COMMENT BY CITY OF SYDNEY, 10 MARCH 2011,

PROPOSED SUPER YACHT FACILITY, (MP 09_0165)

Attachment A

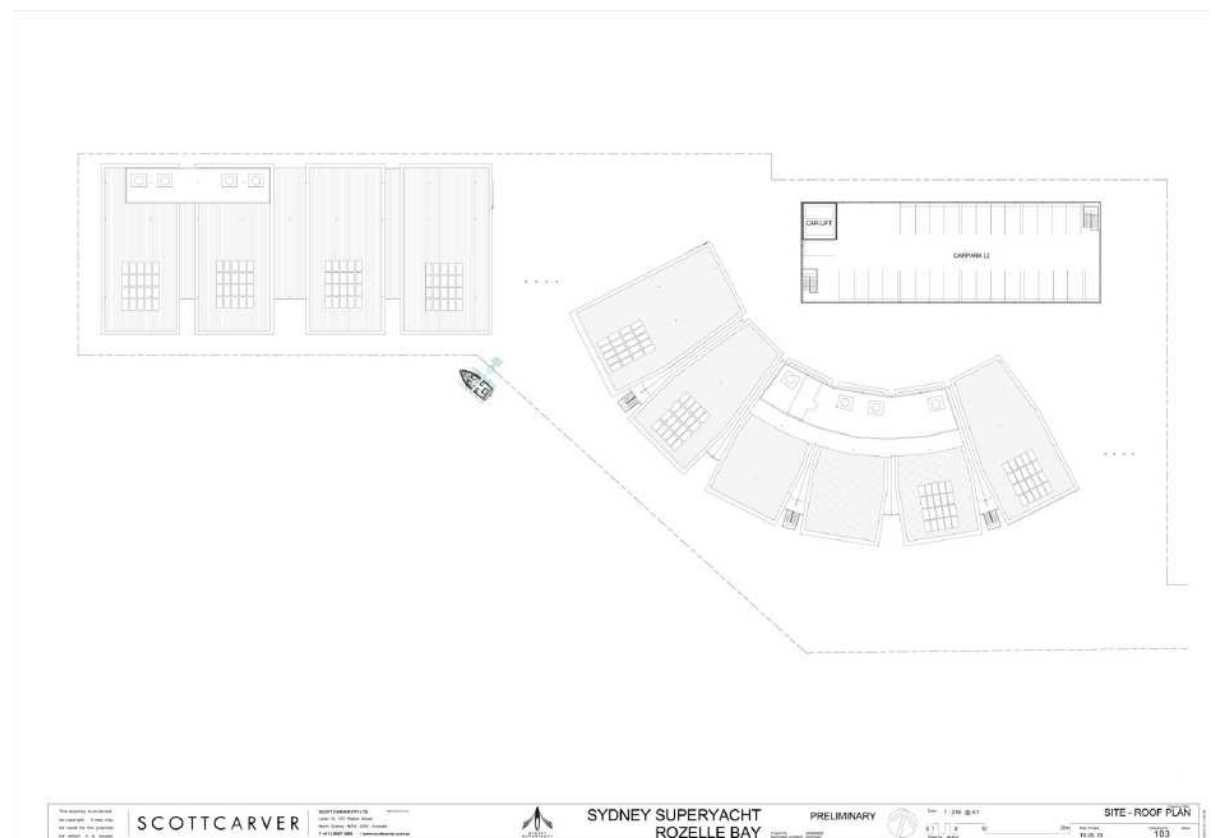
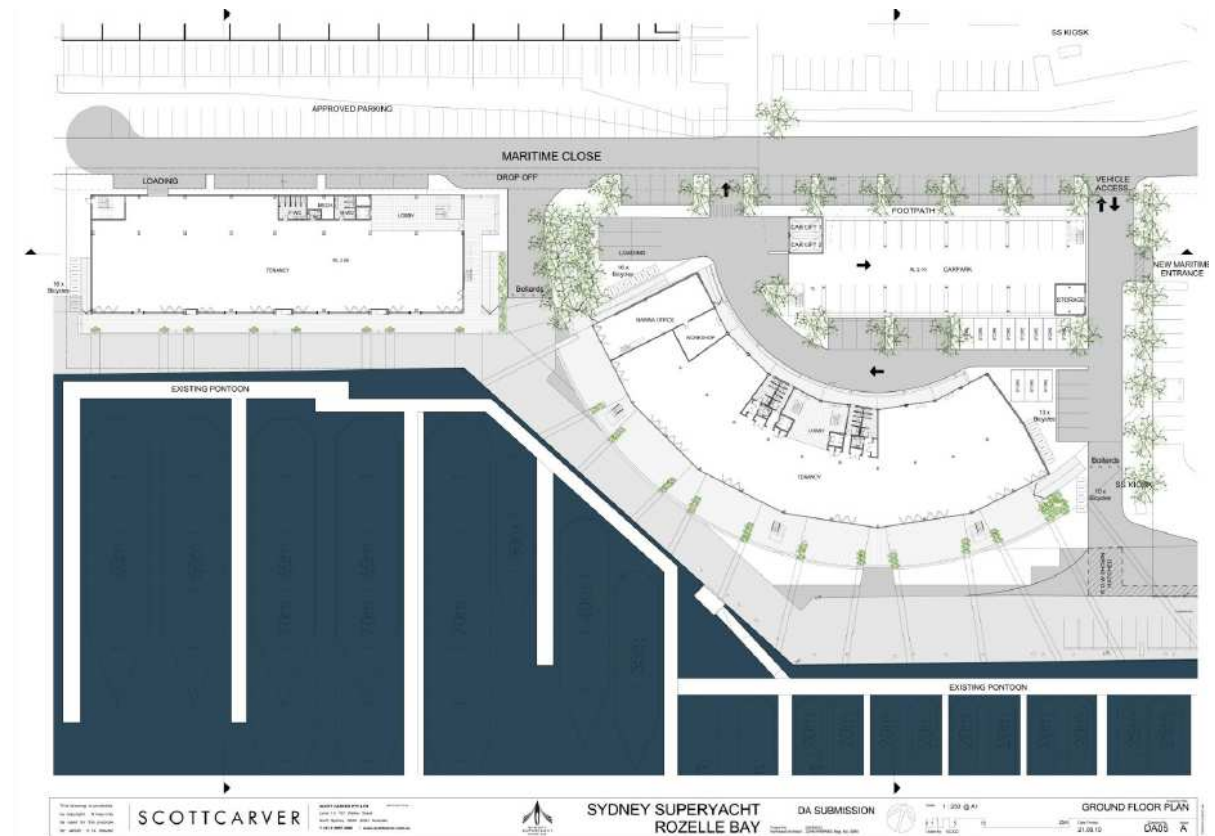
Consent is sought for the construction of 3 buildings: a four storey car park; the eastern building and; the western building (refer Attachment A). These latter buildings would accommodate:

The uses proposed for the eastern building are directly relevant to the operation of a marina facility and are therefore generally compatible. However, the remaining proposed uses, which might be regarded as ancillary, in providing services to those who use the facility, may well become dominant uses over time, and produce a different range of environmental effects than canvassed within this proposal.

Therefore, if consent is granted to the marina then only those uses directly related to that consent should also be granted. The balance of uses – cafes, restaurants, function facilities, hotel (tavern) and package liquor outlets, general bar license and package liquor outlets; and marine based club (“licensed facilities”) – should not be approved with this application, but be required to be subject to a future separate application which can consider their higher impacts independent of the primary use.
